SUBJECT: EVALUATION OF OYSTER CREEK MODIFIED PRESSURE SET-POINT FOR SAFETY/RELIEF VALVE (TAC-2285)

Preliminary Evaluation of Oyster Creek Report On
Safety/Relief Valve Tests

FIGURE 1

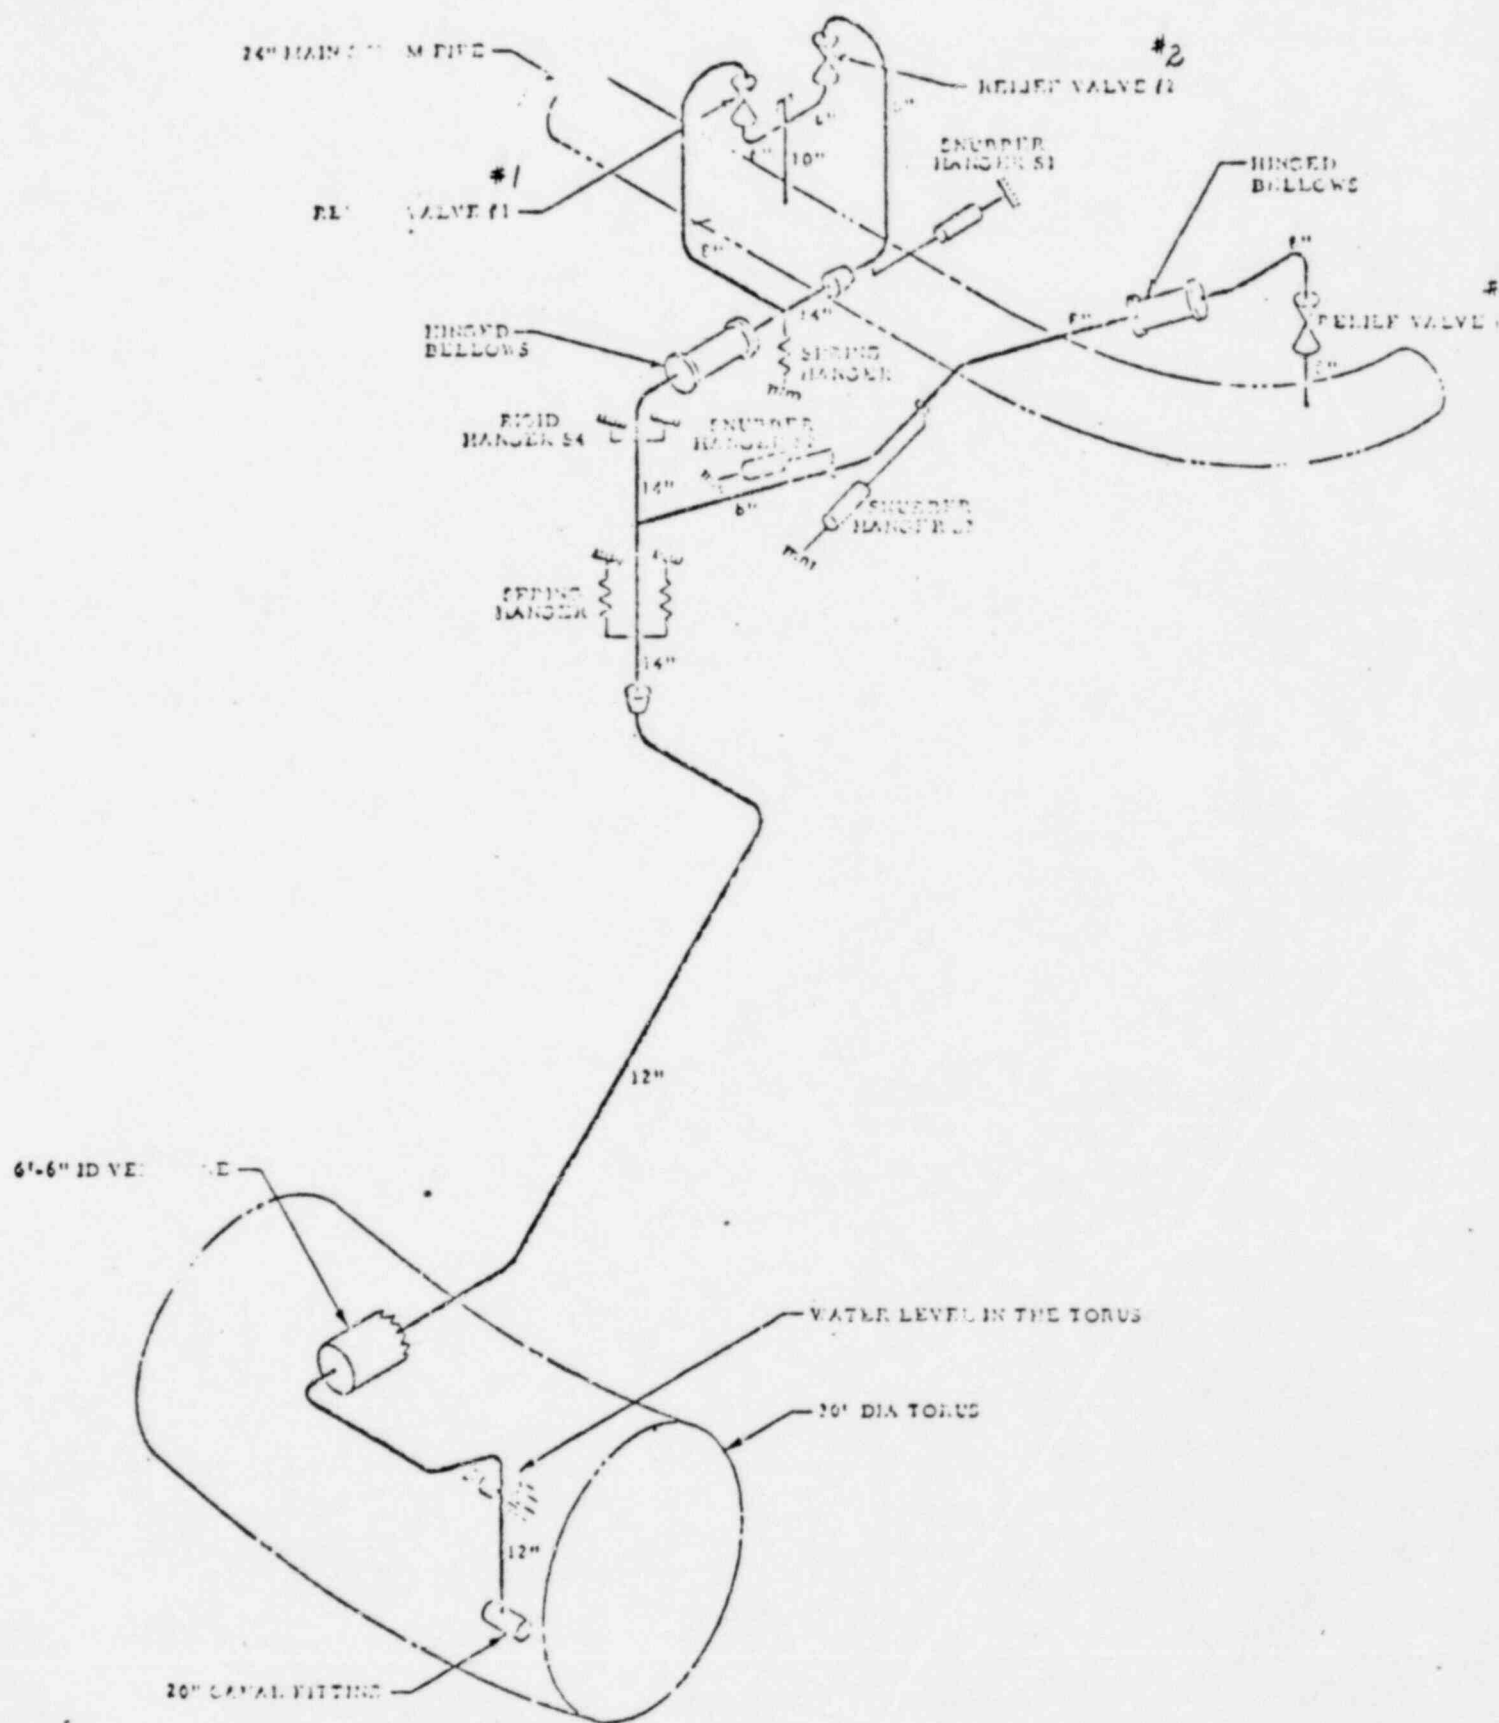
The south header relief valve piping is shown on Figure 1. It consists of individual 8" line jointed into a common 14-inch header. The 14-inch pipe is reduced to 12-inch as it enters the vent line into the torus.

As provided in the JC report, there are approximately 57.0 feet of 8-inch pipe, 68 feet of 12-inch pipe, and 35 feet of 14-inch pipe in the piping system. Based on this information, we estimate that for valve No. 3 the total air volume from the SRV downstream to the discharge point in the torus is 74 cu. ft. The total air volume for valve Nos. 1 and 2 branch lines is 29 cu. ft. This represents about 40% of the total air volume for the valve No. 3.

For certain transients which cause the reactor to be pressurized, No. 3 valve, the lower setpoint valve, will be first activated. Mass and energy released from the primary system through this valve pressurizes the entire SRV discharge system. The water leg is accelerated toward the pool. When the water leg is cleared, the high pressure air inside the No. 3 SRV line discharges into the pool and results in air bubble loads on the surrounding structures.

Note that the air volume stored in the Nos. 1 and 2 branch lines has been compressed and remains inside the line during this event. This air volume within the SRV lines will be heated due to the presence of the high temperature steam. Based on the Monticello test results, the line temperature reaches 300°F within a minute.

Let us postulate that Nos. 1 and 2 are now activated. Meantime, the 40% air volume contained in the branch line is at high pressure and high temperature; the RPV line is also at high temperature. These conditions are similar with the initial conditions for subsequent SRV actuations, which results in significant load increase as Monticello tests show. Let us call this case as "two-valves into a hot pipe."

1. We have concluded that changing the SRV pressure set-points while maintaining the current SRV discharge system will not improve the situation rather potentially aggravating the SRV loads. Therefore, we recommend that all SRVs for Oyster Creek Station should be reset to their original setpoint of 1070 psig.

3. If the structural evaluation indicates a need for load mitigation, we would recommend the following:
 - a. Each SRV should be channeled to its individual line and individual discharge end;

- b. The SRV discharge ends in pool should be distributed evenly;

c. Usage of ramshead as discharge device should be considered.

If the current elbow type of discharge end is maintained, in plant test should be performed after the modification indicated in a and b above is conducted.
